Addendum to Appendix A, Works Approval Application for AGL Tarrone

25 JANUARY, 2011

43283491

PROJECT: AGL Tarrone Peak Loading Power Plant Works Approval Application

TITLE: Predicted Maximum (99.9th Percentile) 1 hour average carbon monoxide concentrations (ug/m³), including background, for four Alstom AE13E2 engines operating at full load

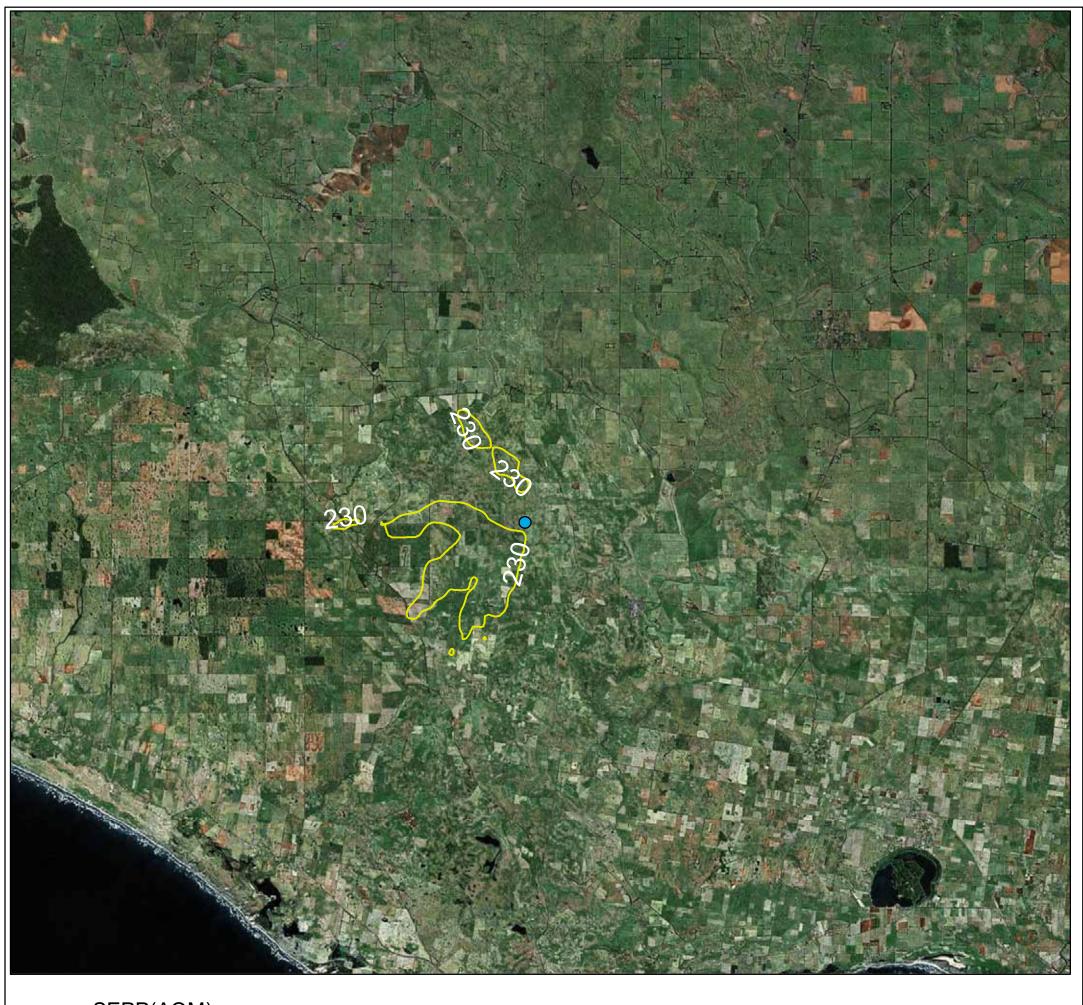
URS has determined an error during the plotting of Figure 4, where the contours for the 99.9th Percentile 1 hour average PM_{2.5} concentration resulting from the use of four Alstom AE13E2 engines operating at full load are presented instead of the contours for 99.9th percentile 1 hour average carbon monoxide contours for the same engine use.

The contours presented in Figure 4 of the document titled 'Final Report - Local Air Quality and Greenhouse Gas Tarrone Power Station' dated 17 June 2010 correctly represented the predicted concentrations however, the base maps were updated when the works approval application was revised and this error occurred. The only change between the Figure 4 associated with the 17 June 2010 report, and this addendum dated 23rd August 2010 is the underlying aerial photography of the modelled area.

The updated results do not change the conclusion of the report.
